**ADDENDUM NO. 2**

**BRIDGE BUSWAY RTE. 71 OVER RTE. 72-088-177-03-01**

PROJECT TITLE: NEW BRITAIN - HARTFORD BUSWAY
NEW BRITAIN SECTION A

DRAWING TITLE: SOUTHWEST WINGWALL PILE LAYOUT & DETAILS

## PILE LAYOUT PLAN - SOUTHWEST WINGWALL

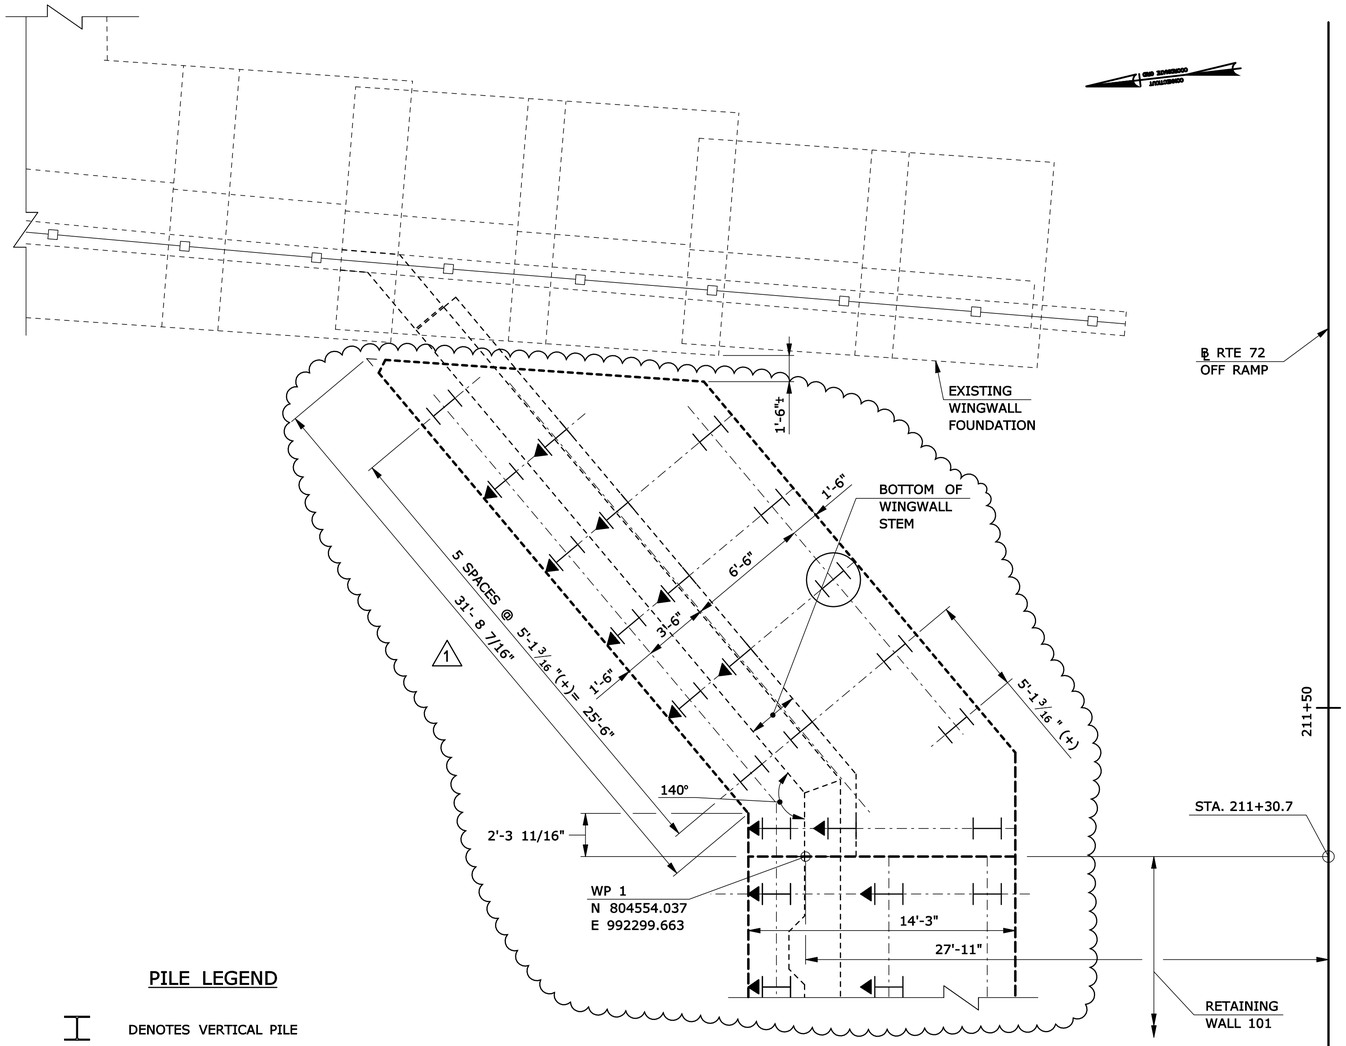
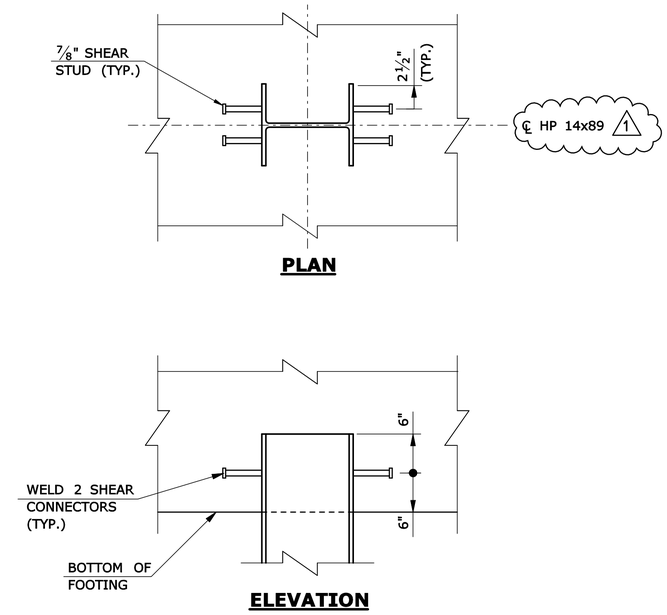
| REV. | DATE | REVISION DESCRIPTION | SHEET NO. |
|---|---|---|---|
| 1 | 10/7/11 | ADDENDUM NO. 2 - REVISED PILES & FOOTING | 03.02.007.A2 |

DRAWING TITLE:
SOUTHWEST WINGWALL PLAN & ELEVATION

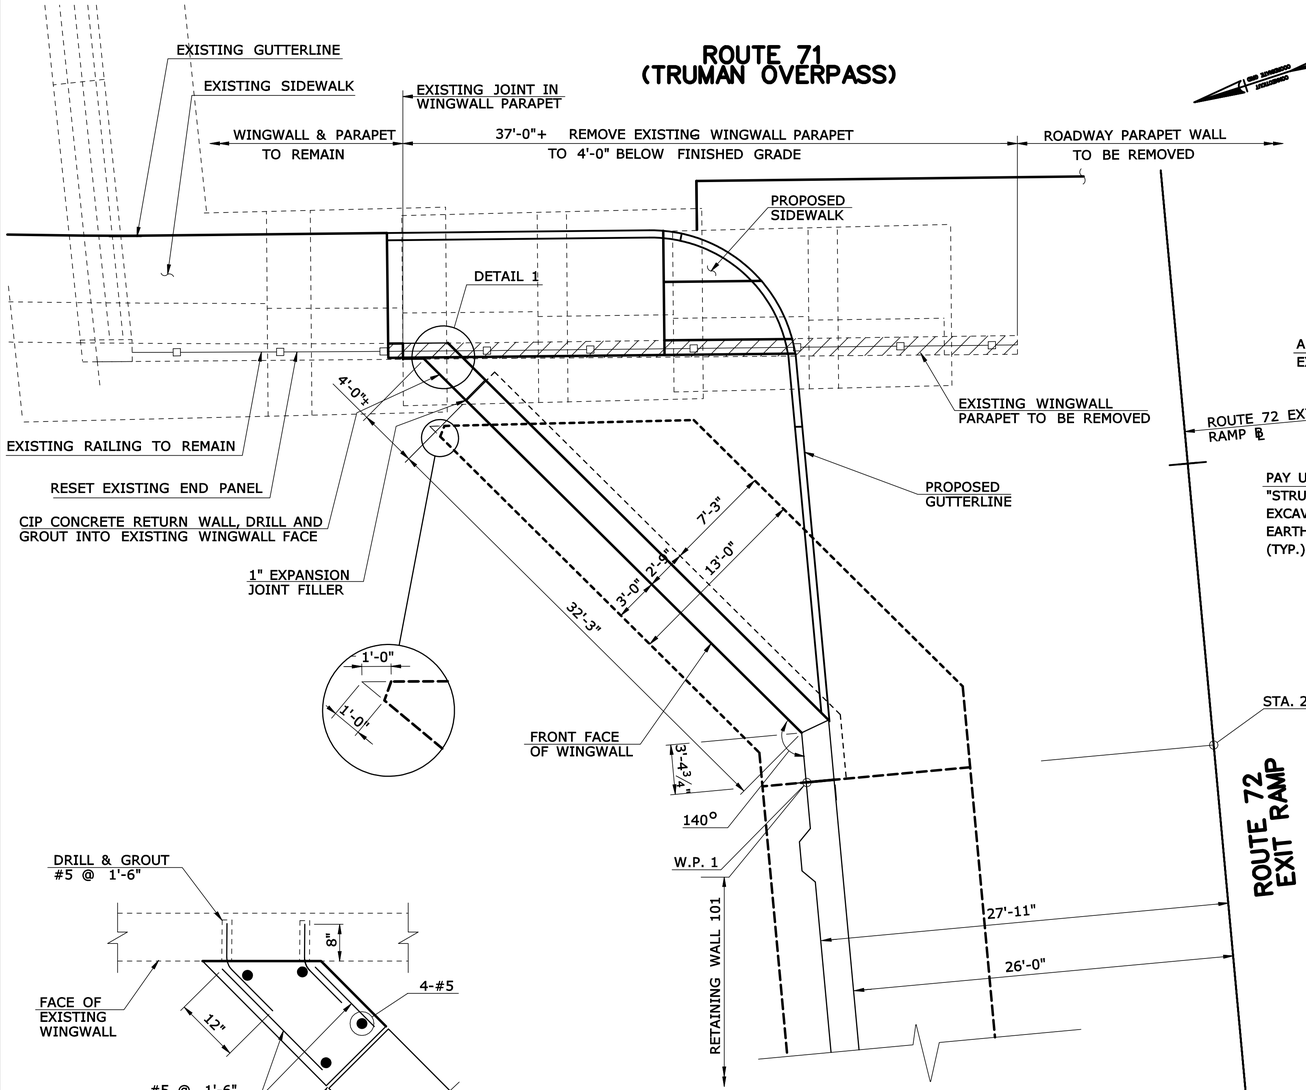
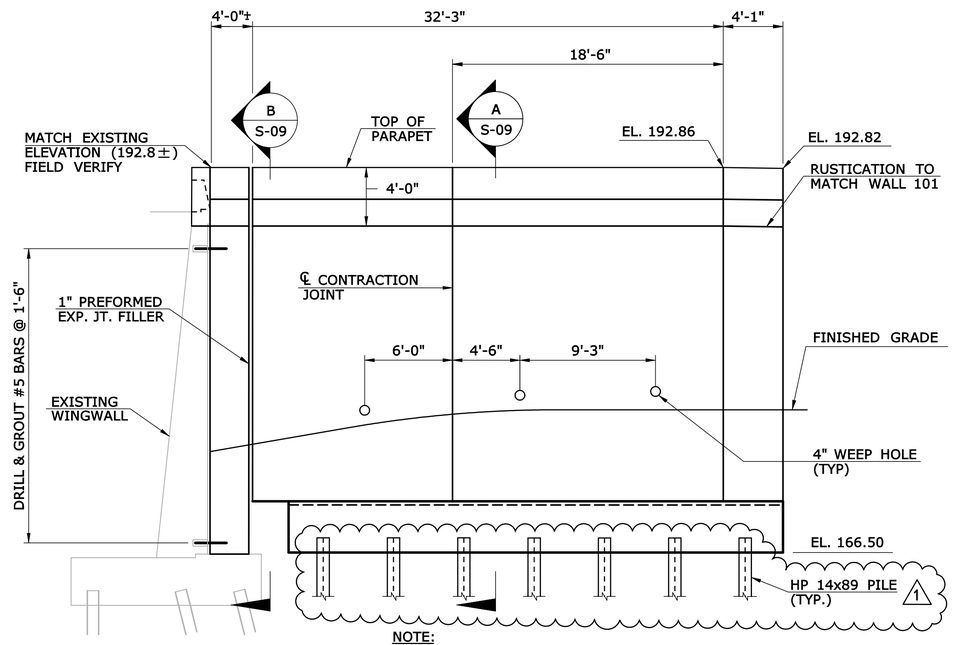
| REV. | DATE | REVISION DESCRIPTION | SHEET NO. |
|---|---|---|---|
| 1 | 10/7/11 | ADDENDUM NO. 2 - REVISED PILE SIZE | 03.02.008.A2 |

DRAWING TITLE: **SOUTHWEST WINGWALL DETAILS**

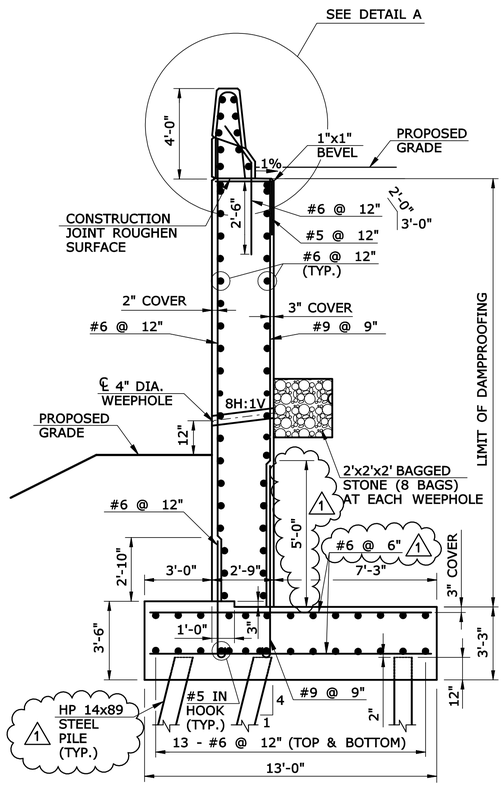
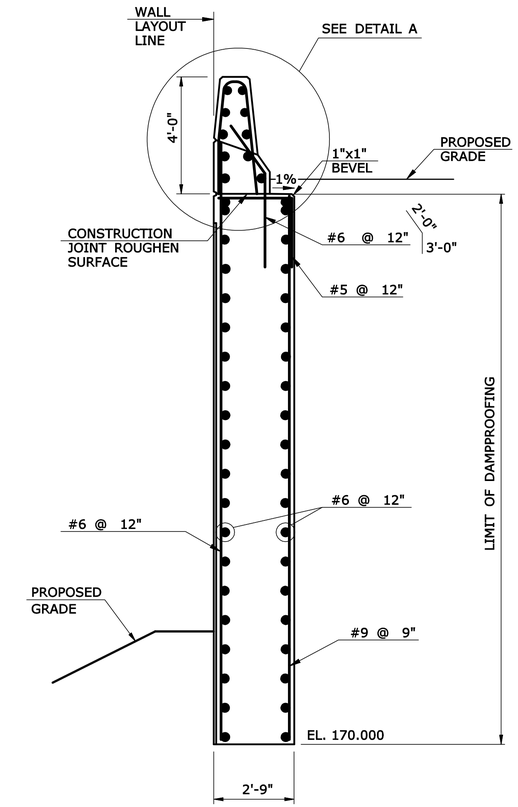
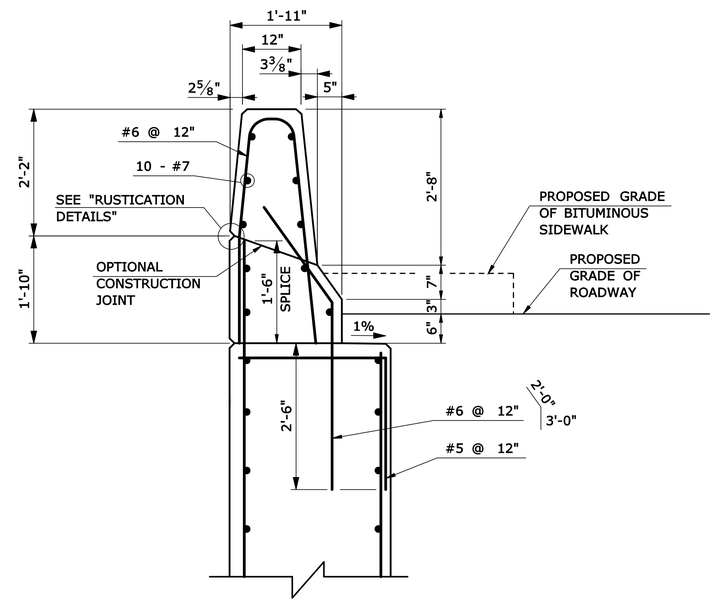
| REV. | DATE | REVISION DESCRIPTION | SHEET NO. |
|---|---|---|---|
| 1 | 10/7/11 | ADDENDUM NO. 2 - REVISED PILE & REINF. | 03.02.009.A2 |
